# LAUREL LAKE VILLAS

## HUDSON, OHIO

**AHBR DESIGN REVIEW**  
**MAY 27TH, 2026**

# STAFF COMMENTS 2026

# CUYAHOGA, VILLA 1 – DESIGN OPTIONS

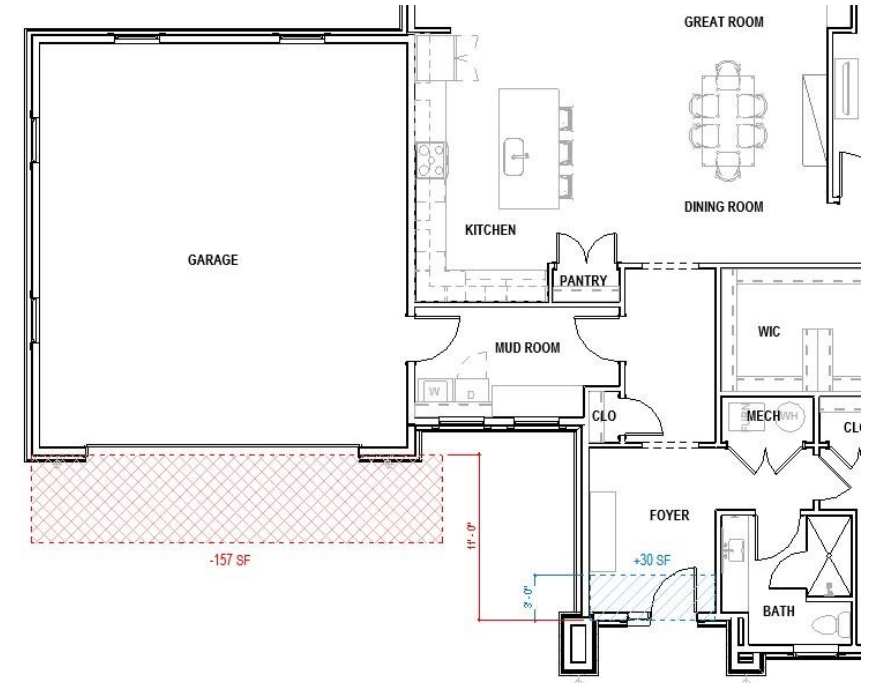
1. Section IV-3 (b)(3) – Forward facing garages.
2. Section IV-3 (b)(2) – Front Faceoff main body is 18" in front of all wings.
3. Section IV-3(b) – Main body must be largest mass.
4. Section IV-3(d)(3) – Material used must be consistent on all sides.
5. Section III-1(g)(3) – Sunroom foundation material.
6. Window trim – Consistent on all elevations.
7. Section IV-3(c) – Roof to be same shape as main body.

# CUYAHOGA, VILLA 1 – REVISED ELEVATIONS

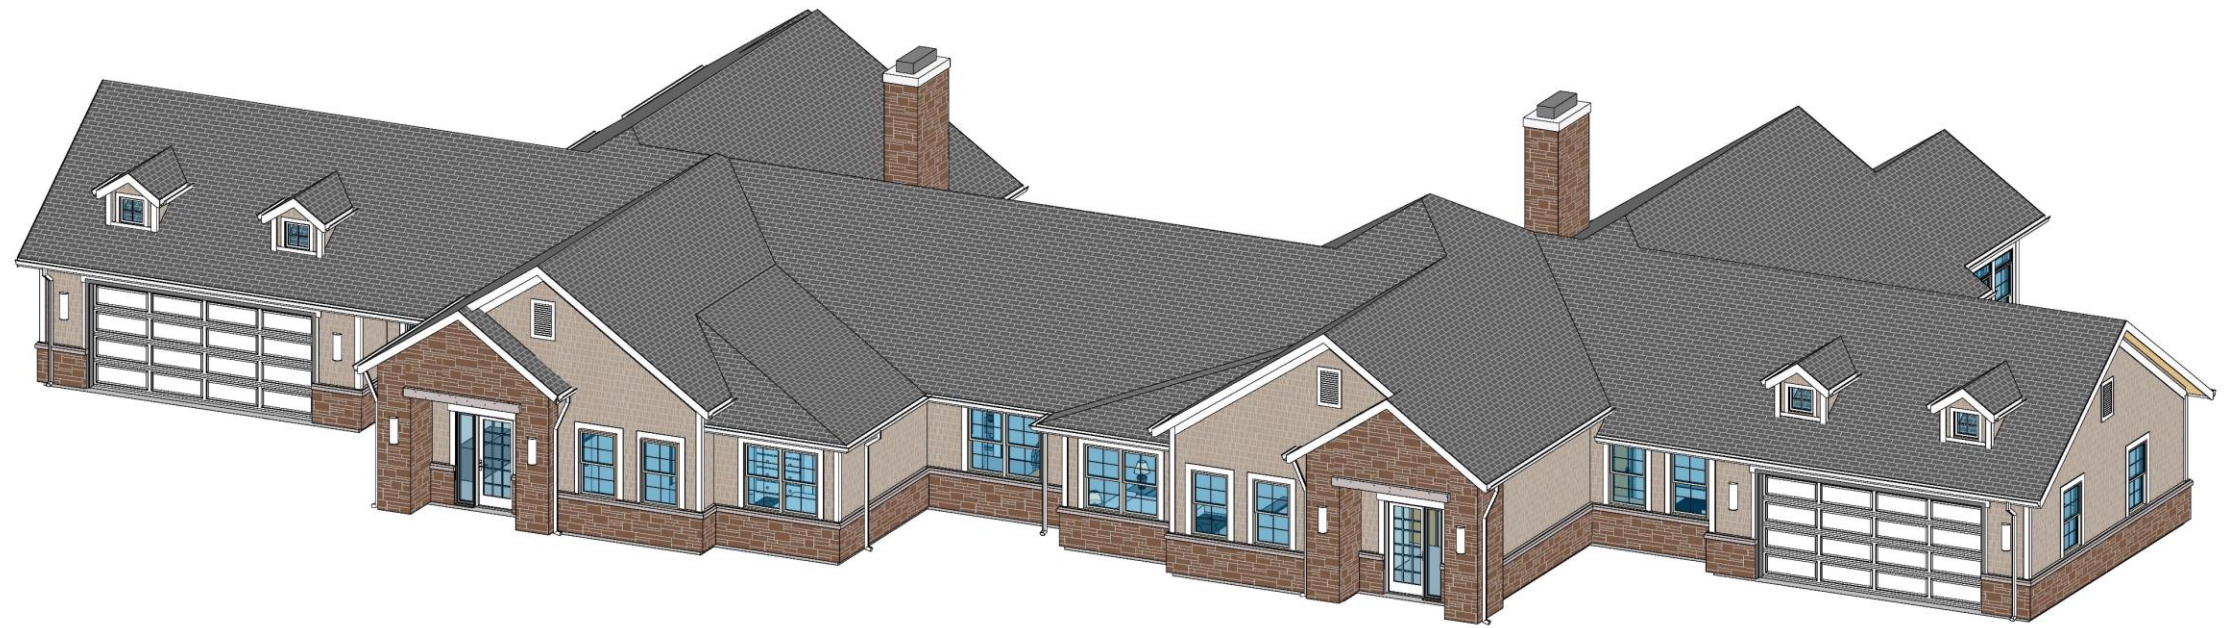
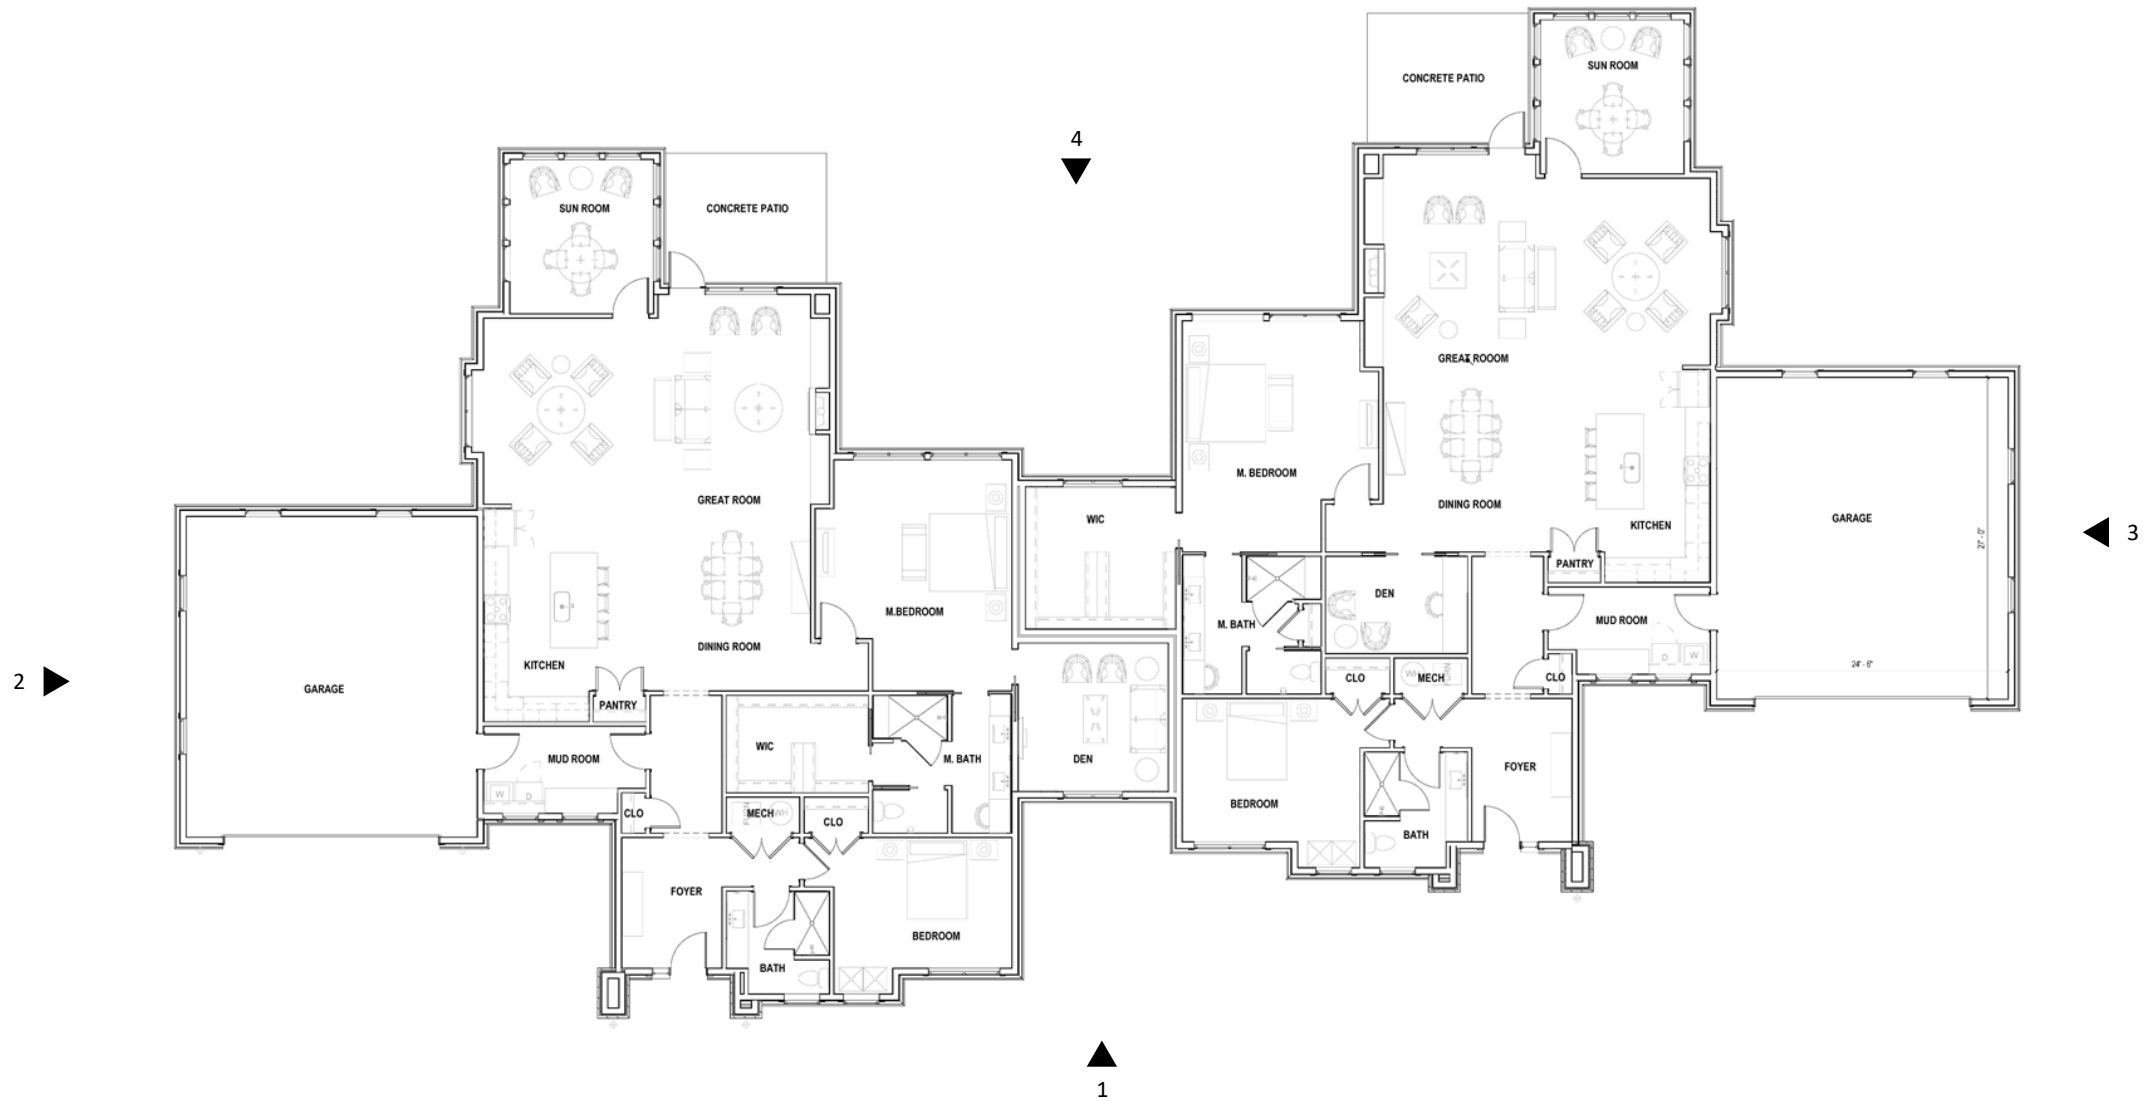
1. Section IV-3 (b)(3) – Forward facing garages.
2. Section IV-3 (b)(2) – Front Faceoff main body is 18” in front of all wings.
3. Section IV-3(b) – Main body must be largest mass.
4. Section IV-3(d)(3) – Material used must be consistent on all sides.
5. Section III-1(g)(3) – Sunroom foundation material.
6. Window trim – Consistent on all elevations.
7. Section IV-3(c) – Roof to be same shape as main body.

# VILLA 2 – DESIGN OPTIONS

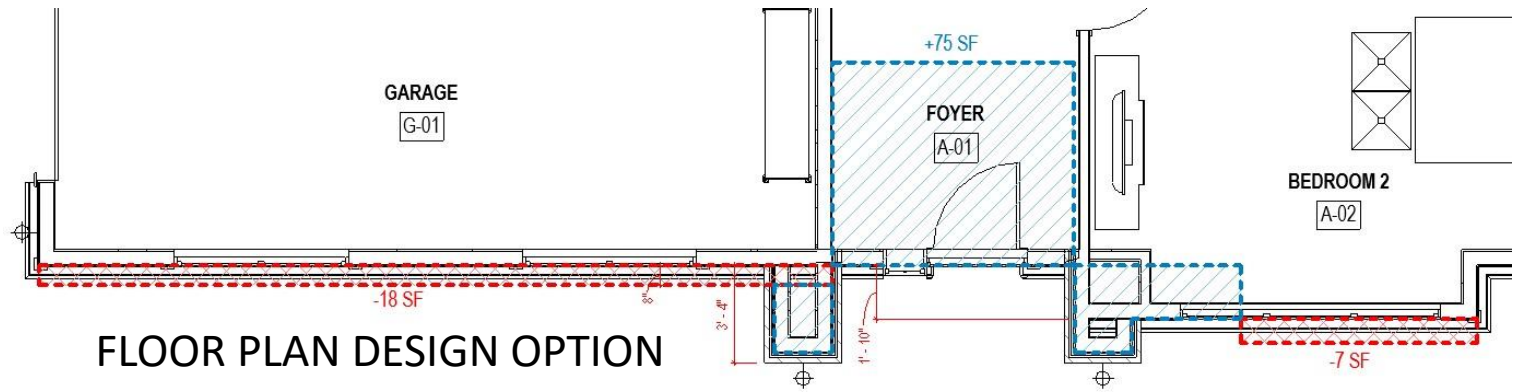
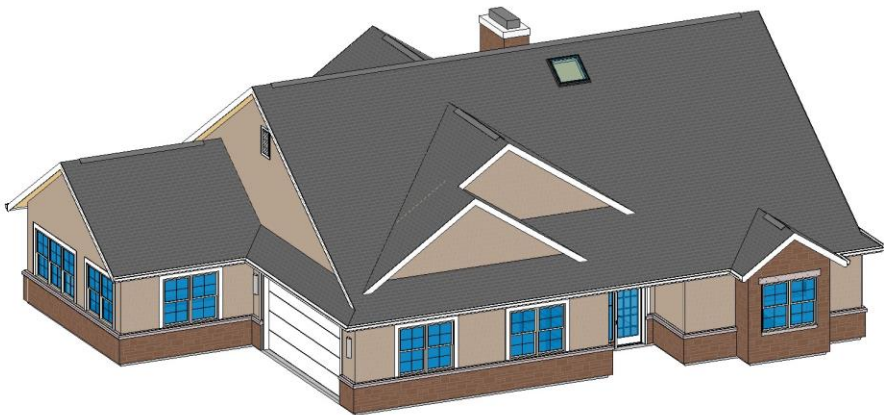
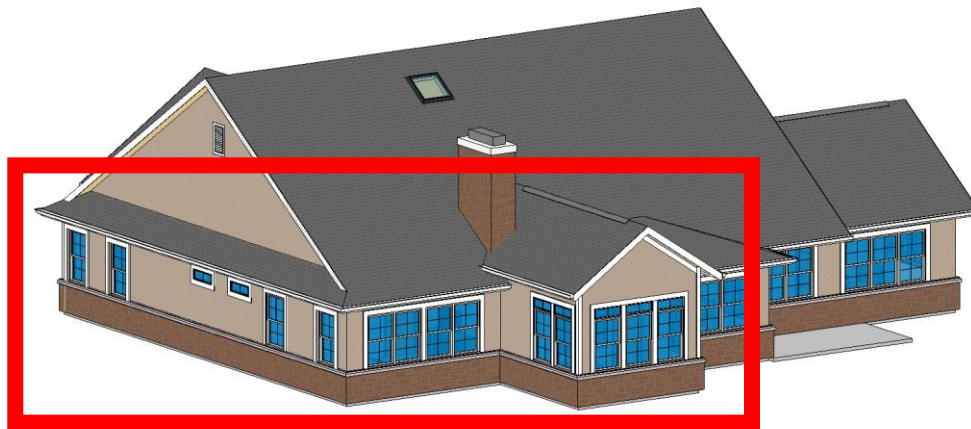
1. Section IV-3(g)(2) – 5' projections treated as wings
2. Section IV-3(e)(4) – Typical window for most windows
3. Section IV-3(f)(1) – Consistent detail applied throughout
4. Section III-1(d)(5) – Fenestration every 12'
5. Section IV-3(c) – Roof to be same shape as main body.
6. Section III-1(g)(3) – Sunroom foundation material.
7. Window trim – Consistent on all elevations.
8. Section III-1(g)(3) – Sunroom foundation material.

# VILLA 2 – REVISED ELEVATIONS

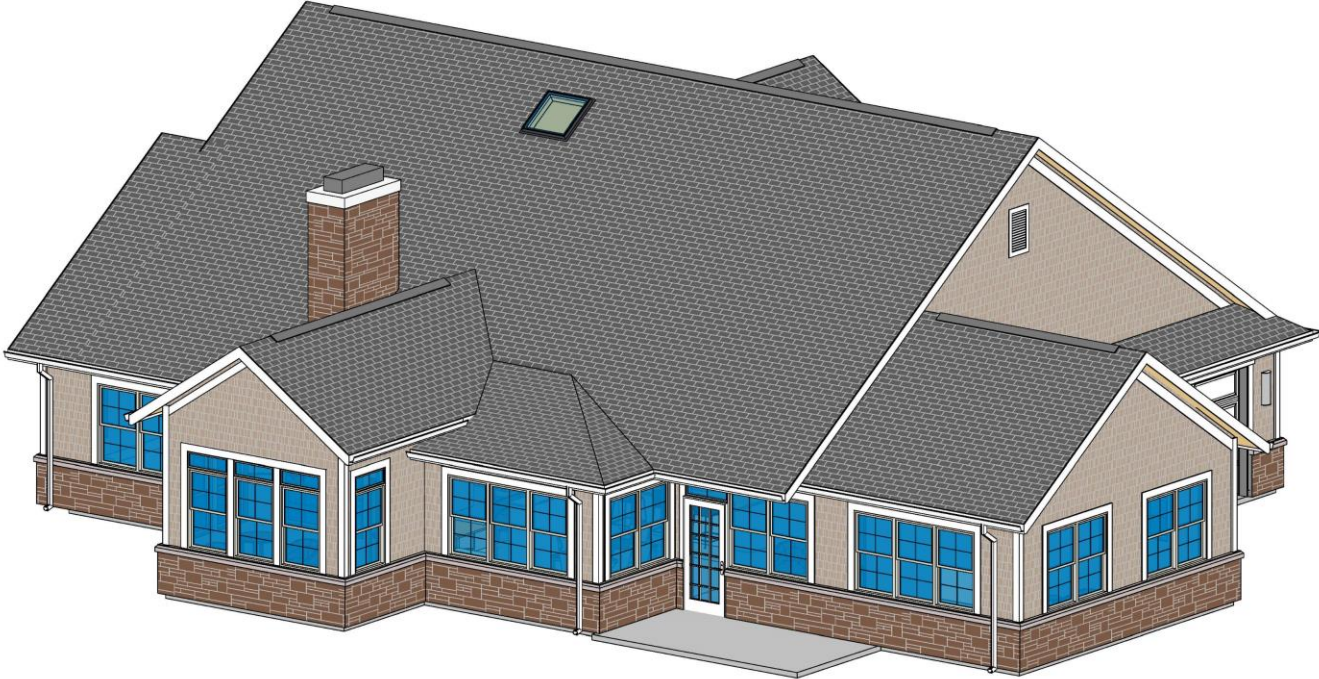
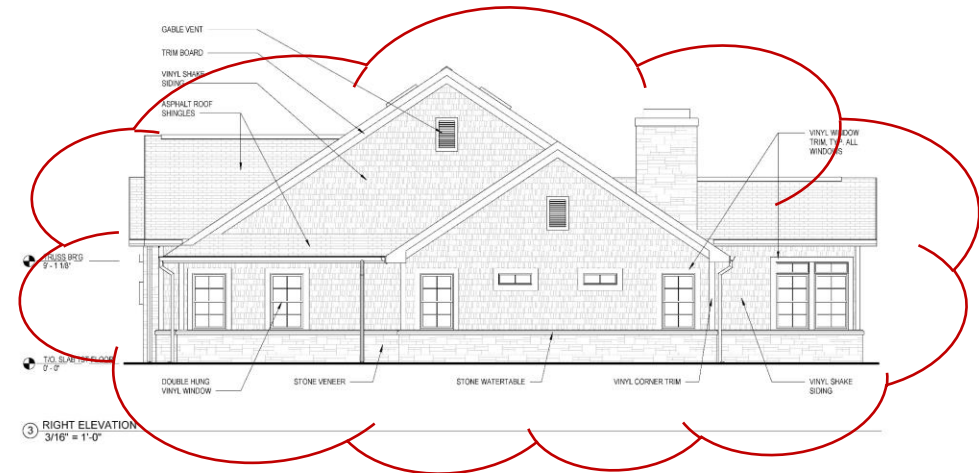
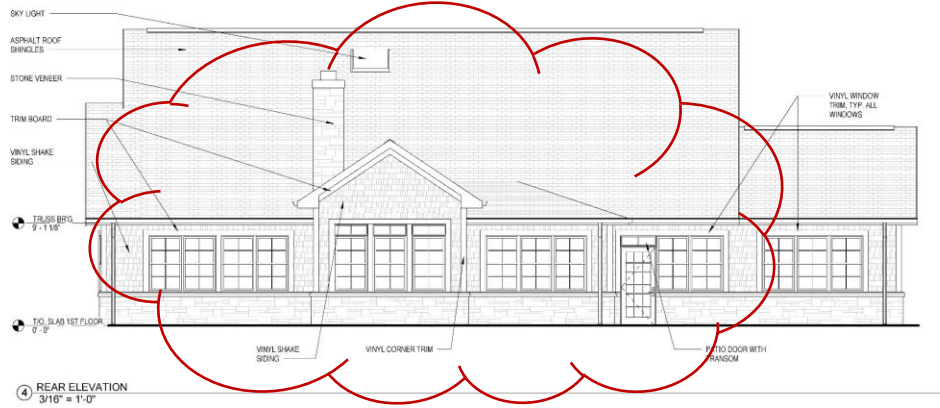
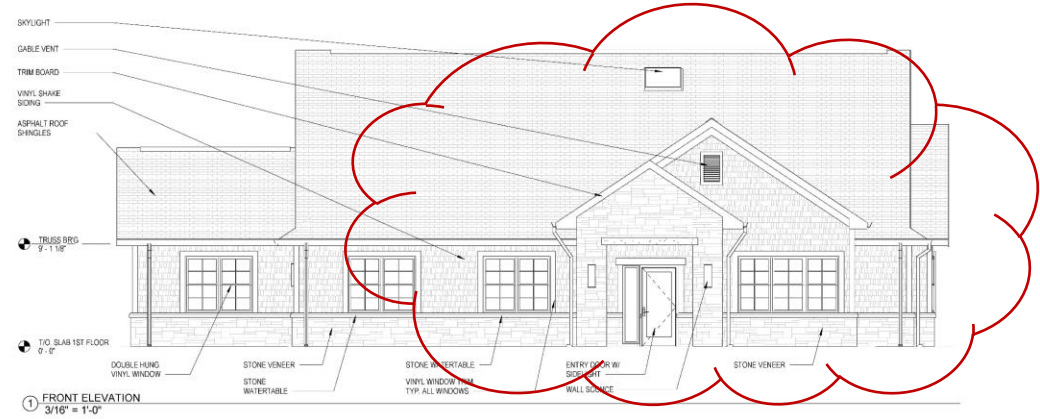
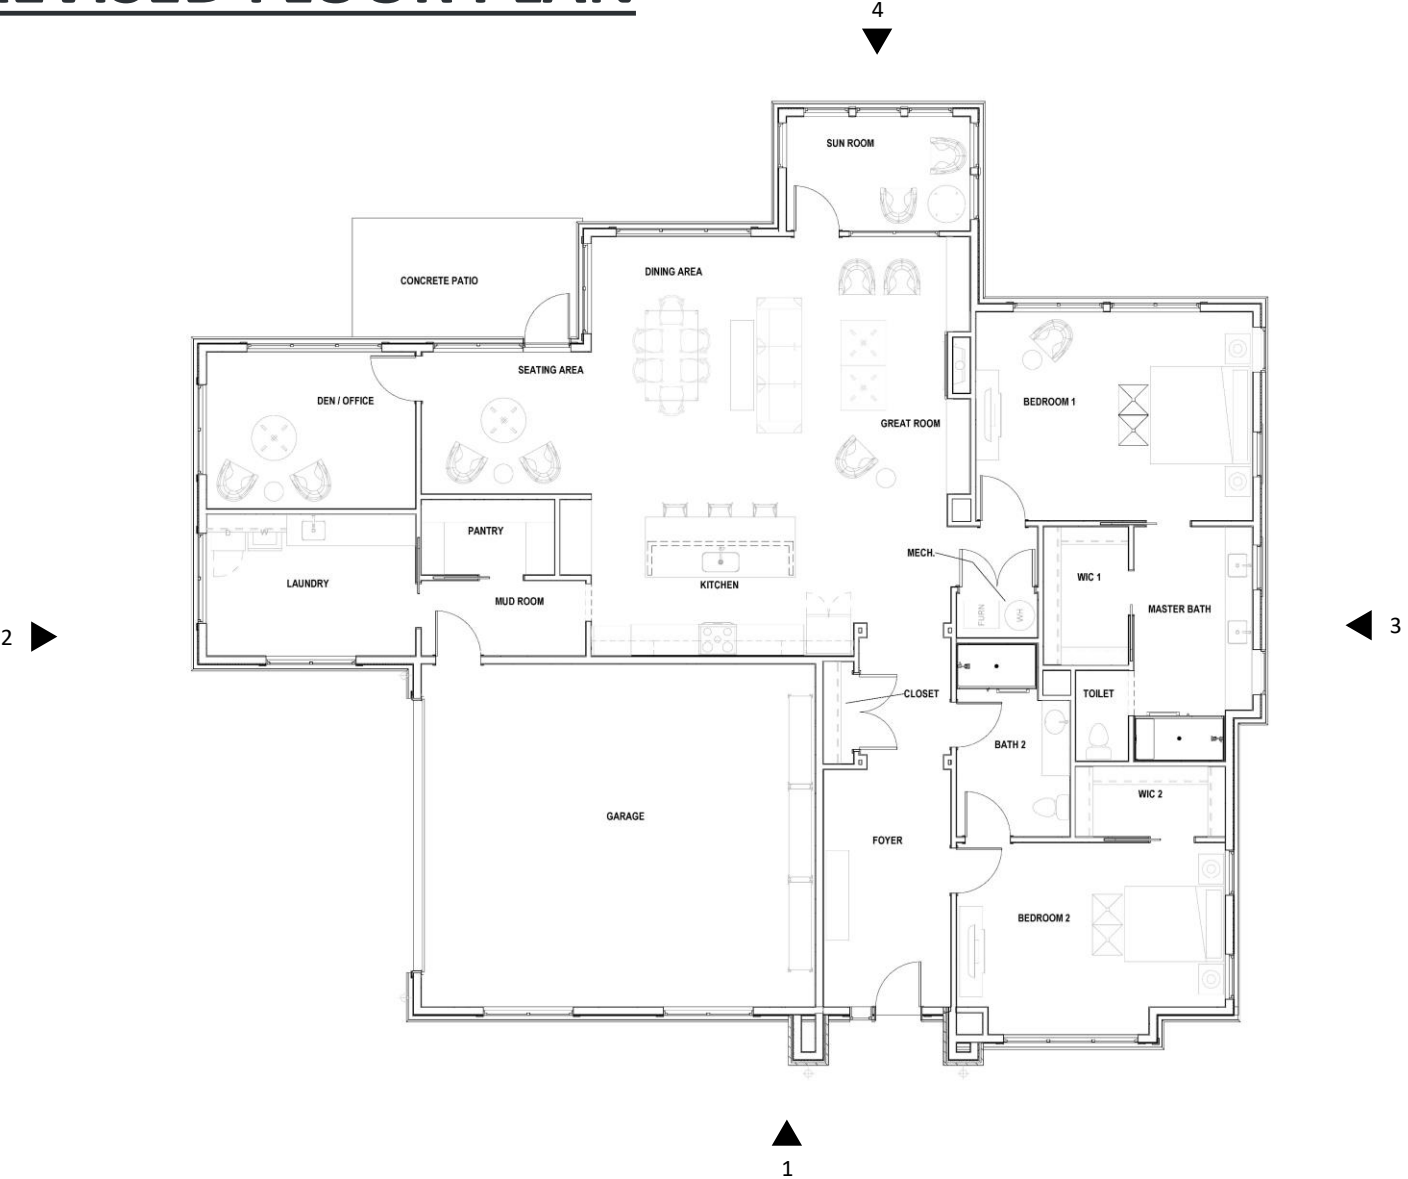
1. Section IV-3(g)(2) – 5’ projections treated as wings
2. Section IV-3(e)(4) – Typical window for most windows
3. Section IV-3(f)(1) – Consistent detail applied throughout
4. Section III-1(d)(5) – Fenestration every 12’
5. Section IV-3(c) – Roof to be same shape as main body.
6. Section III-1(g)(3) – Sunroom foundation material.
7. Window trim – Consistent on all elevations.
8. Section III-1(g)(3) – Sunroom foundation material.
